1958 Corvette: Service Bulletin: Electric Windshield Wiper Information

Subject: Electric Windshield Wiper Information
Model and Year: 1958 Passenger Cars and Trucks
Source: Chevrolet Technical Service Bulletin
Bulletin No: DR #359
Section: I
Date: May 28, 1958

FIGURE #1.

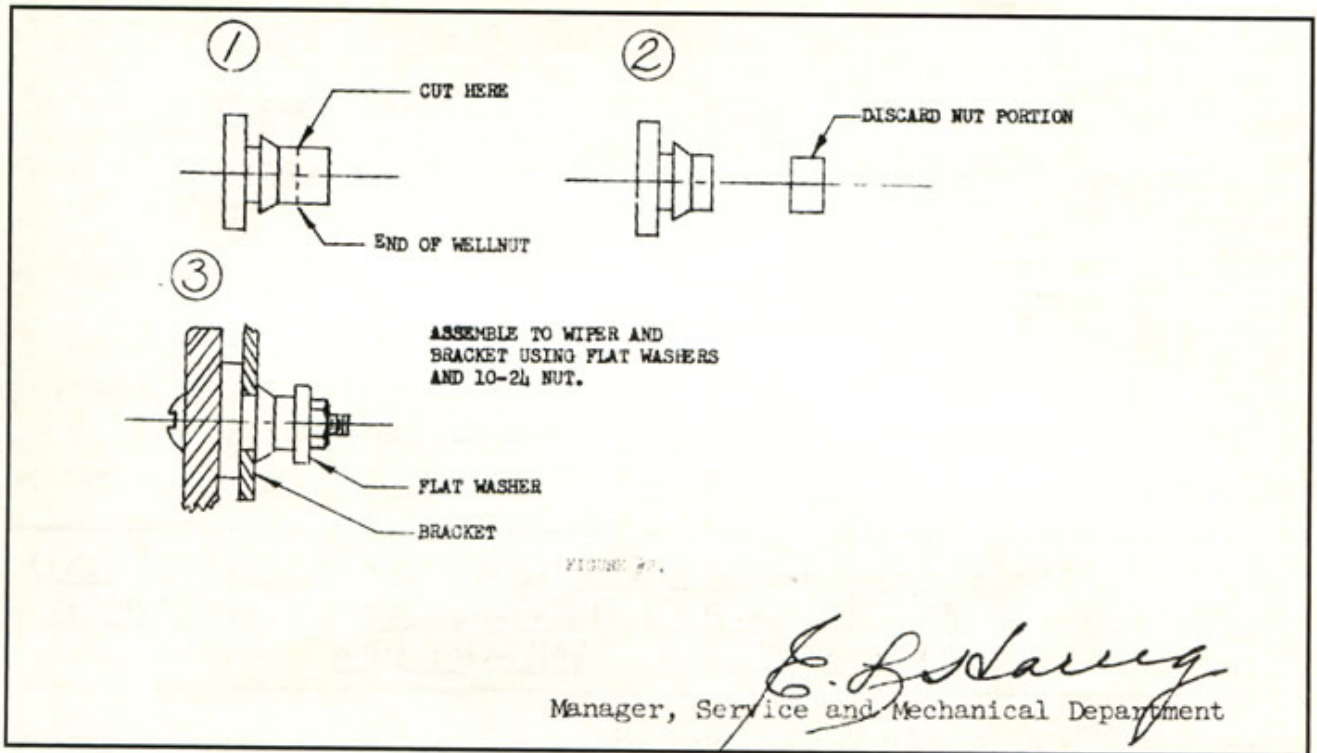
A parking spring has been released for production and service which enables the motor to shut off without depending on the resistance of the wiper blades. The spring is designed to clear the revolving arm in the "ON" position and stop the arm in the "PARK" position when switch is turned off. Figure #1 shows installation of parking spring.

A more durable replacement cam stop is available for service. Figure #1 shows details of installation. The existing tab must be bent flat before installation of the new stop.

Parking Spring and Cam Stop Unit
Includes: 1-4904857 - Parking Spring
1-4904878 - Cam Stop
